THE REGIONAL MUNICIPALITY OF NIAGARA

TENDER 2017-T-104 (RN 17-04)

**Regional Municipality of Niagara
South Side Low Lift Sewage Pumping Station Upgrades
City of Niagara Falls**

ADDENDUM NO. (4)

TRANSFORMER PAD
TP-103-48 2K
FOR UP TO 2000 KVA TRANSFORMER

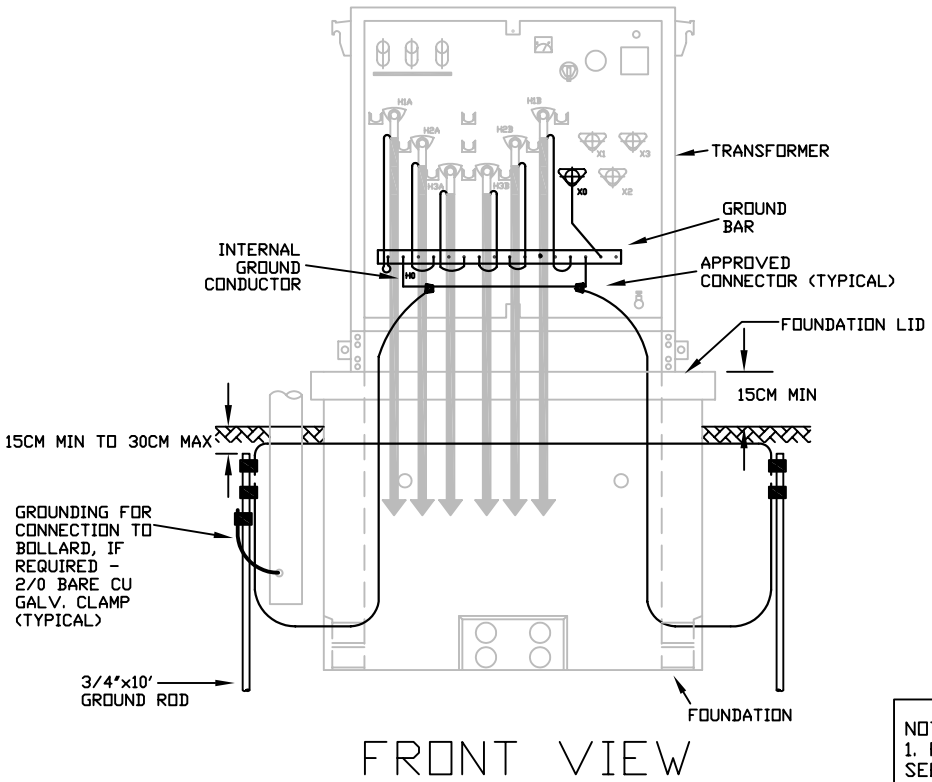
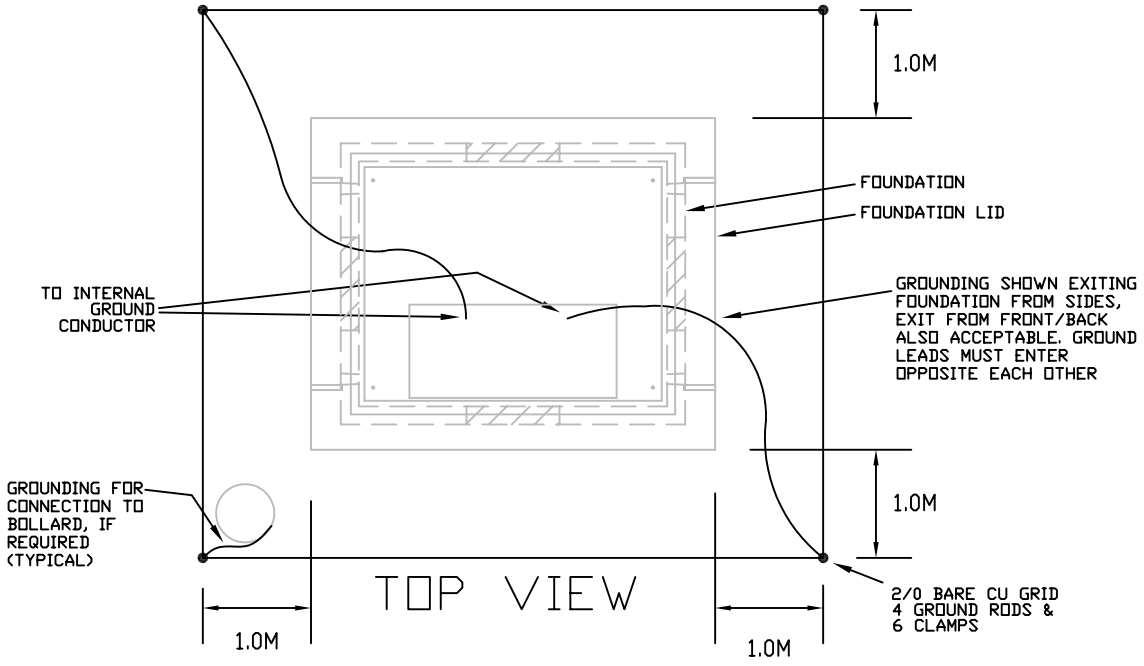
Q3 New transformer pad to be provided as per Q/A 13. Is existing transformer pad to be removed and replace with new pad? Drawing only shown secondary ductbank from transformer pad to pumping station. Is primary ductbank and primary cable to be remained in place while pad is being replaced? There is no details or notes regarding ground grid for the new pad. Is existing ground grid to be reused?

A3 The existing transformer pad (base, vault and lid) is to be removed and replaced with a new pad (base, vault and lid). Please provide a “Hygrade TP-103-48 2K Precast Pad” (**attached**) with the optional solid base. The Contractor will be required to provide temporary primary power during the replacement of transformer and pad (base, vault and lid). The existing primary feed duct bank can be re-used, the Contractor is responsible for providing all necessary transitions from the existing duct bank to new pad. A new transformer grounding grid is to be provided, see the **attached** ground grid for reference. The Contractor is to provide impact protection on the driveway side of the transformer with a minimum of 2 bollards, location to be verified with onsite engineer.
